Site Accessibility Evaluation

**Taco Bell Store #017314
(Pre)**

**7230 Pendleton Pike
Lawrence, IN 46226**

Pre Inspection

Finding: 9

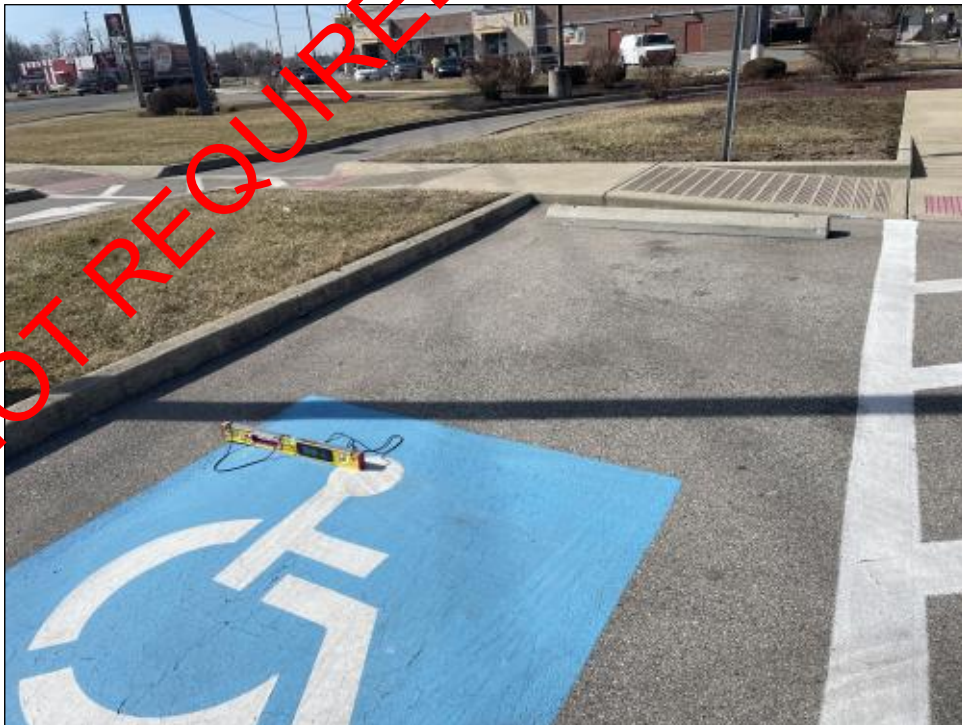
The cross slope (narrow dimension) of the parking stall exceeds 2%.

The running and cross slope in an accessible parking stall and the access aisle must not exceed 2%.

Entire left half of stall >
2%

WITHIN REASONABLE CONSTRUCTION TOLERANCE

NOT REQUIRED TO BE MODIFIED

Finding: 34

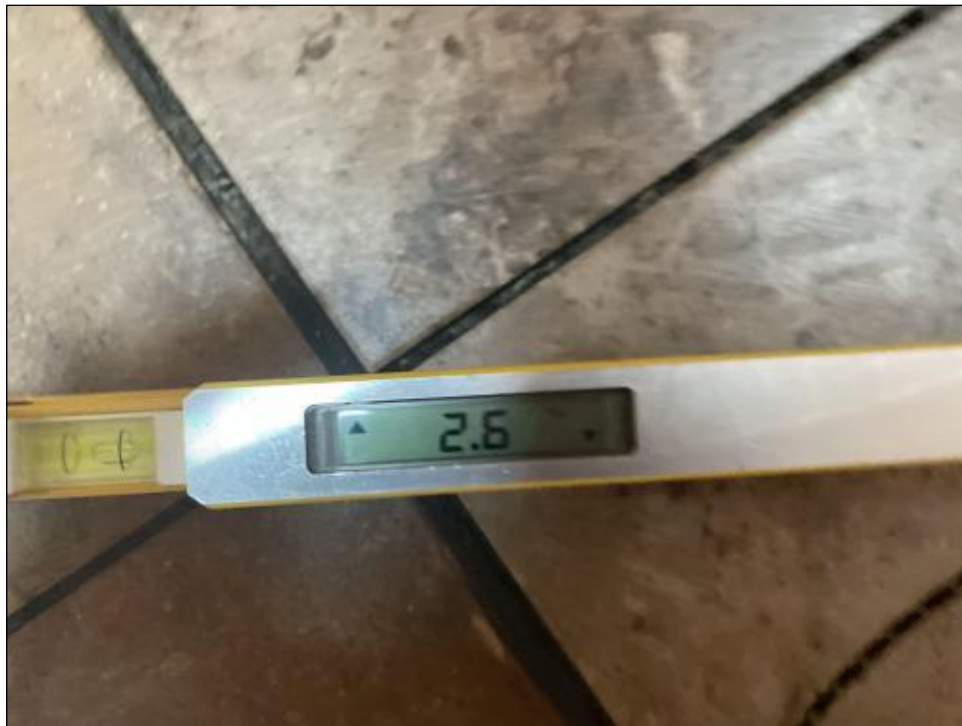
The clear floor space required in the restroom is not flat (2% or 1:48 maximum slope) in all directions.

Changes in level are not permitted at required clear floor or ground space except that slopes not steeper than 1:48 shall be permitted.

Lifted tile >2%
